Workgroup Consultation Response Proforma

CMP435: Application of Gate 2 Criteria to existing contracted background

Respondent details	Please enter your details	
Respondent name:	Michelle MacDonald Sandison	
Company name:	SSEN Distribution	
Email address:	michelle.macdonaldsandison@sse.com	
Phone number:	01738 342183	
Which best describes your organisation?	<input type="checkbox"/> Consumer body <input type="checkbox"/> Demand <input checked="" type="checkbox"/> Distribution Network Operator <input type="checkbox"/> Generator <input type="checkbox"/> Industry body <input type="checkbox"/> Interconnector	<input type="checkbox"/> Storage <input type="checkbox"/> Supplier <input type="checkbox"/> System Operator <input type="checkbox"/> Transmission Owner <input type="checkbox"/> Virtual Lead Party <input type="checkbox"/> Other

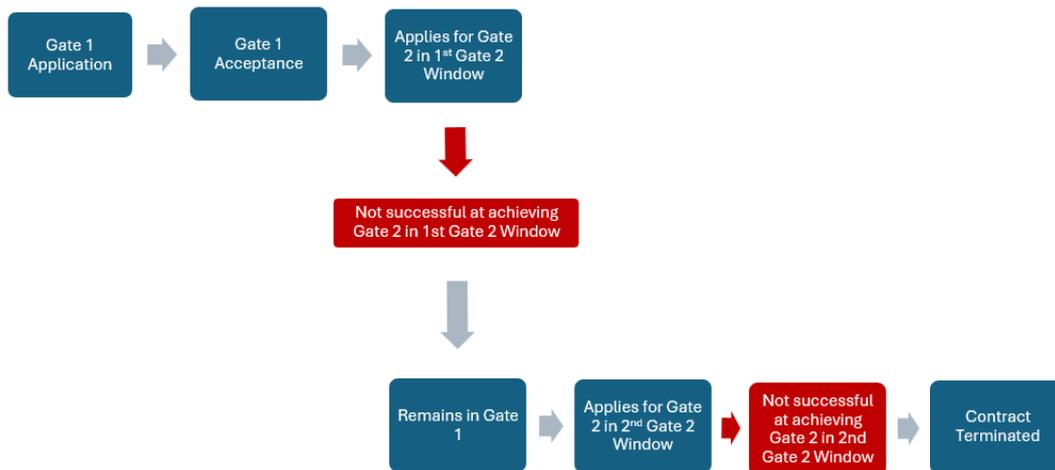
SSEN Distribution is supportive of introducing back stop dates into Gate 1 Agreements, however we have concerns that 3 years is too long for the longstop date and without the presence of a financial instrument at the Gate 1 stage there is a lack of incentive for projects to adequately progress. This could lead to an inflated view of the future connections queue and impact upon anticipatory investment decisions. We also have concerns that the longstop date can be extended by the ESO. CUSC connection agreements already contain a “backstop date” that is frequently ignored and arbitrarily moved back. We would question what controls and processes are in place to ensure the longstop date is not treated in the same way. The risk associated with the current approach is that the Gate 1 “queue” will be as big or bigger than the current queue, as of August 2024, due to the ease of entry and retention of the contract.

As an alternative to the proposed backstop date of 3 years, SSEN Distribution propose a link to the Gate 2 application windows. If a project does not move from Gate 1 to Gate 2 within the next two Gate 2 application cycles following acceptance of a Gate 1 offer, then that project should be terminated and must reapply.

We have illustrated our proposal in the below image, to help visualise the process we are suggesting.
